STATE OF FLORIDA  
DEPARTMENT OF ENVIRONMENTAL PROTECTION  
NOTICE OF FINAL PERMIT

Facility I.D. No. 0530233  
DEP Permit No. PSD-FL-194F  
Polk Power Station  
Polk County

DEP File No. 1050233-007-AC Permit No. PSD-FL-194F Emission Unit 001 NO <sub>x</sub> Emissions Reduction SIC No. 4911
---

## PSD PERMIT MODIFICATION (PSD-FL-194F)

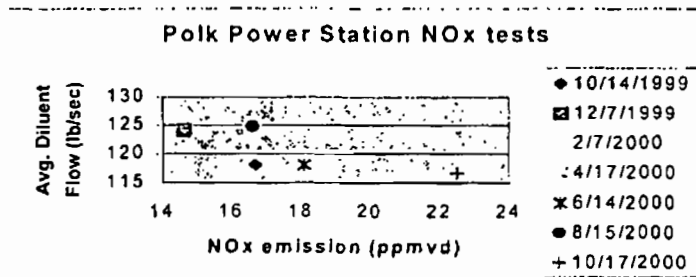
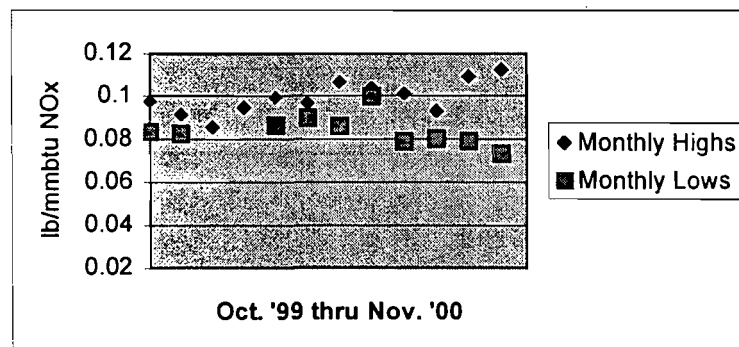
TEC has cautioned against an analysis of NO<sub>x</sub> emissions as compared to diluent flow, noting that "although the diluent flow is an important parameter for controlling NO<sub>x</sub> emissions, a more appropriate measure is the ratio of diluent flow to syngas flow. On an overall basis, this ratio represents the proportional flows of NO<sub>x</sub> controlling diluent and the syngas flow. Additional complicating factors that prevent a straightforward linear analysis of diluent flow rate or ratio and the NO<sub>x</sub> emissions rate include the varying composition of the syngas, and the heating value of the fuel. Although these data are presented, TEC recommends against using these data to establish firm operating ranges due to the variability in other factors that significantly contribute to NO<sub>x</sub> emissions from this combustion turbine." Since diluent flow will likely increase with generating load (up to some load point) and since syngas flow is directly proportional to unit load, it is likely that a measure of diluent flow to syngas flow (which the applicant purports is more appropriate) makes some sense, as in the case of reviewing the entire load range of a combustion turbine. However, the Department wishes to better understand the impact of diluent flow on NO<sub>x</sub> emissions, given that the diluent is the control media for NO<sub>x</sub>. Since the tests are at a similar load point, the syngas flow and its associated variability can be effectively ignored. This yields a chart similar to the one above, indicating some level of correlation (albeit with 7 data points) between the diluent flow

TEC has cautioned against an analysis of NO<sub>x</sub> emissions as compared to diluent flow, noting that *“although the diluent flow is an important parameter for controlling NO<sub>x</sub> emissions, a more appropriate measure is the ratio of diluent flow to syngas flow. On an overall basis, this ratio represents the proportional flows of NO<sub>x</sub> controlling diluent and the syngas flow. Additional complicating factors that prevent a straightforward linear analysis of diluent flow rate or ratio and the NO<sub>x</sub> emissions rate include the varying composition of the syngas, and the heating value of the fuel. Although these data are presented, TEC recommends against using these data to establish firm operating ranges due to the variability in other factors that significantly contribute to NO<sub>x</sub> emissions from this combustion turbine.”* Since diluent flow will likely increase with generating load (up to some load point) and since syngas flow is directly proportional to unit load, it is likely that a measure of diluent flow to syngas flow (which the applicant purports is more appropriate) makes some sense, as in the case of reviewing the entire load range of a combustion turbine. However, the Department wishes to better understand the impact of diluent flow on NO<sub>x</sub> emissions, given that the diluent is the control media for NO<sub>x</sub>. Since the tests are at a similar load point, the syngas flow and its associated variability can be effectively ignored. This yields a chart similar to the one above, indicating some level of correlation (albeit with 7 data points) between the diluent flow and NO<sub>x</sub> emissions. Given the very limited amount of tests, one initial conclusion which might be drawn is that NO<sub>x</sub> emissions are likely to be less than 19 ppmvd if the diluent flow is held to 120 lb/sec or higher.

Each analysis of the facility data referred to herein suggests that a NO<sub>x</sub> limit of 0.09 lb/MMBtu (approximately 18 ppmvd) would likely be reasonable, given that certain changes may be required.

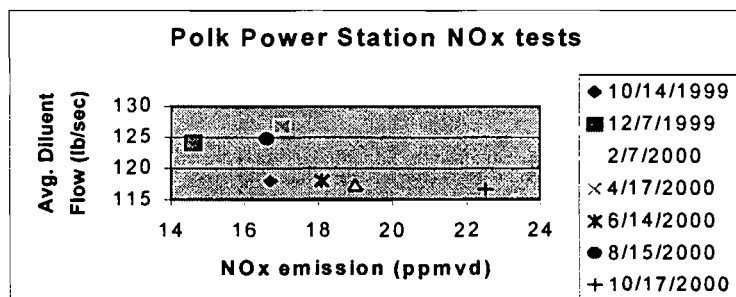
Applicant Comment: The cost to control NO<sub>x</sub> emissions through the use of an SCR system on Polk Unit 1 presented in the analysis submitted to FDEP was based on a limited number of estimated costs. Since SCR has not been required for any IGCC installation in the United States, it is not possible to compare the cost of installing an SCR at the Polk facility to the cost of installing an SCR at another IGCC facility. The conclusion that SCR must be applied to Polk Unit 1 simply because the cost of NO<sub>x</sub> control is lower than what the cost of NO<sub>x</sub> control might be at the CPV Gulf Coast facility does not seem to take into account environmental, energy, and other costs as prescribed in the definition of BACT. In addition, this conclusion does not seem to consider the operation of 'other similar facilities' or 'manufacturer's research' as called for in Specific Condition A.50 of the Polk Power Station Title V Permit.

Department Response: It does not seem unreasonable to review the cost of applying an SCR to TEC's Polk Unit 1 (an IGCC unit) as it compares to the cost of applying an SCR to a gas/oil fired combined cycle unit. In fact, such a review leads to an initial conclusion that there is little difference in these costs.

Figure 1

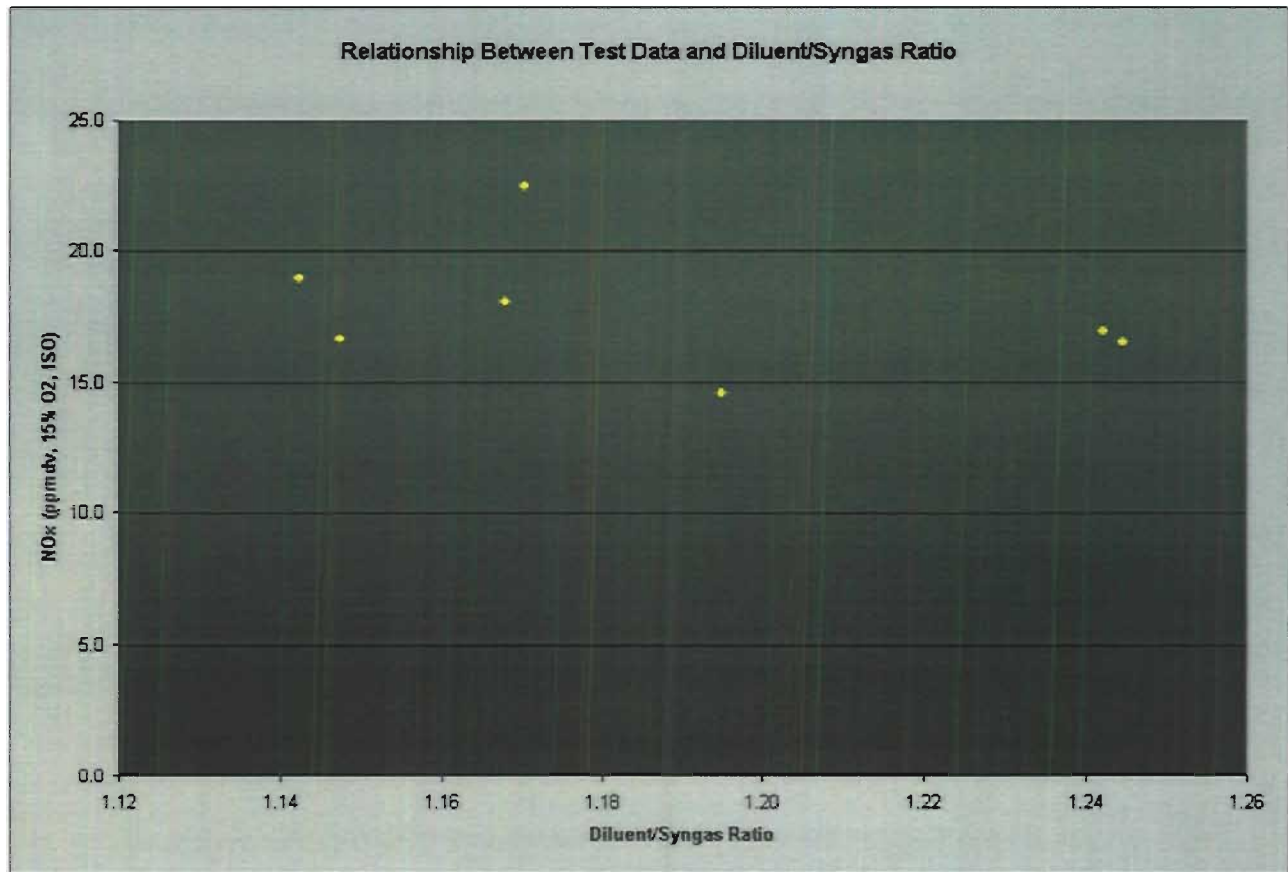
*These data, presented graphically in the enclosed Figure 1, show no strong correlation between diluent/syngas flow rate and NO<sub>x</sub> emissions rate. A linear regression analysis demonstrated a large error in fitting the data, with a regression coefficient of 0.14 thus, it may be concluded that factors other than the diluent/syngas flow ratio considerably affect the emissions performance of the combustion turbine.*

FIGURE 1. (Page 2 of 2)

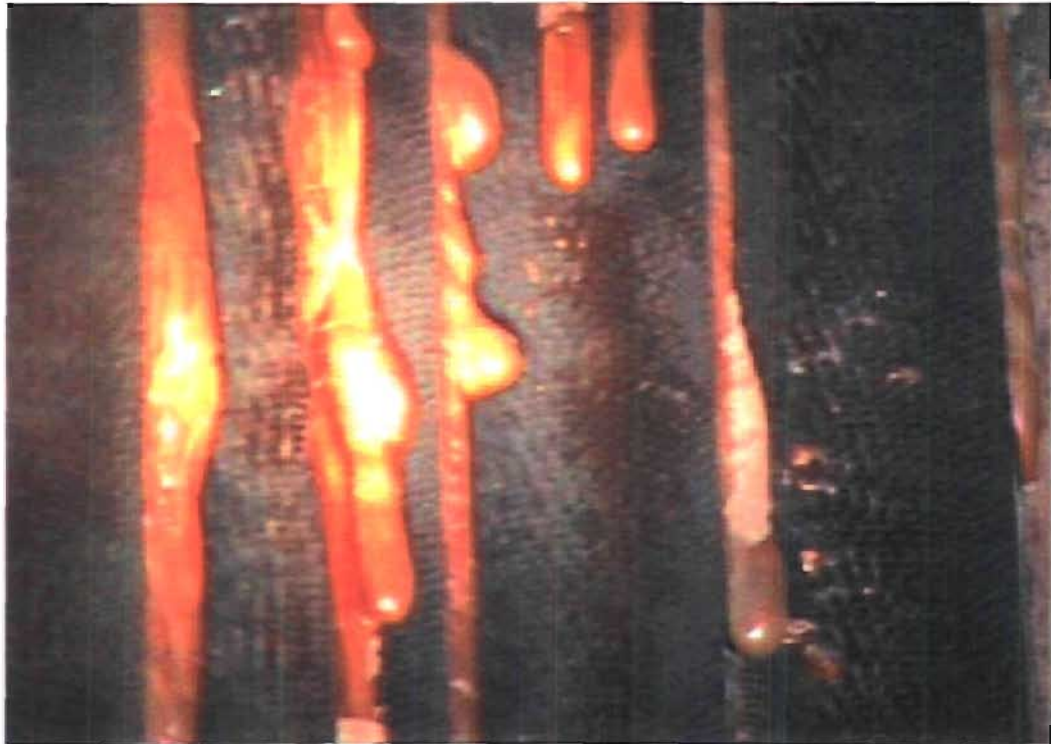
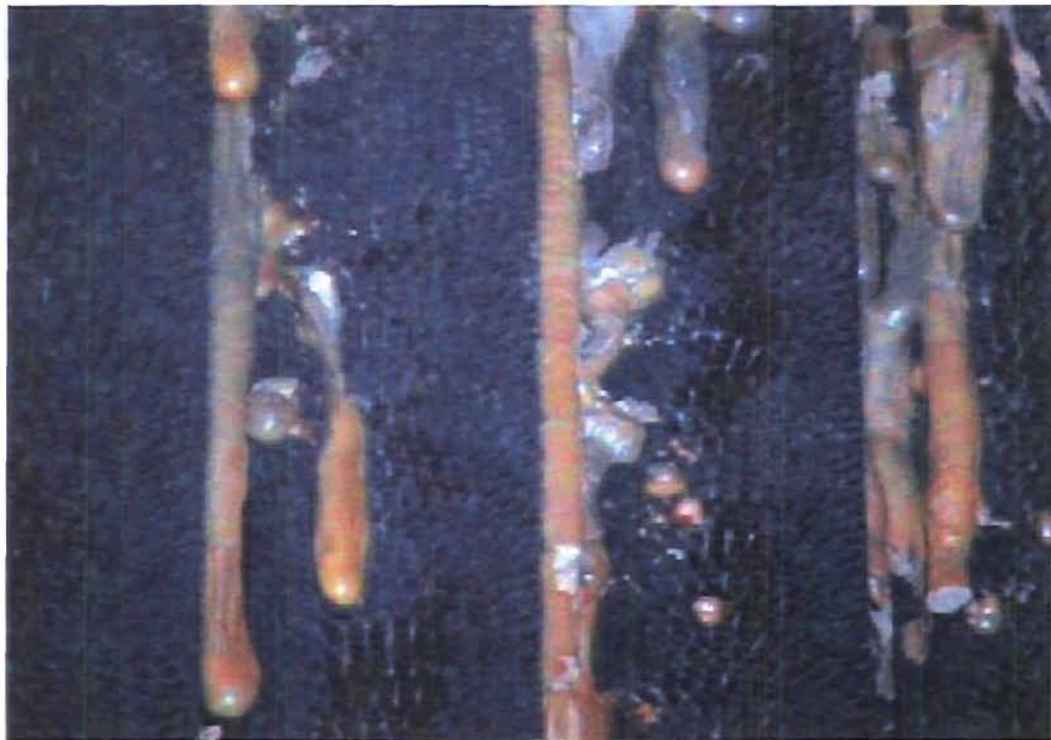
Of particular concern in this project is the use of the SCR catalyst on a sulfur-containing fuel. Yellow deposits composed of sulfur, and sulfur compounds have been noted from the high-pressure evaporator tubes to the low-pressure economizer. The temperature range associated with these deposits includes the normal operating temperature range of typical SCR catalysts. Several photographs were taken during a recent equipment shut-down that indicated the presence of sulfur compound deposition in the equipment, which is an overriding technical concern for fouling of the SCR control system. A sampling of these photographs is included in Figure 1 to support the assertion that the sulfur compounds in the exhaust stream present a technical obstacle to the use of an SCR emissions control system. Thus, there are significant amounts of sulfur and sulfur compounds in the exhaust stream that will adversely affect the performance of an SCR.
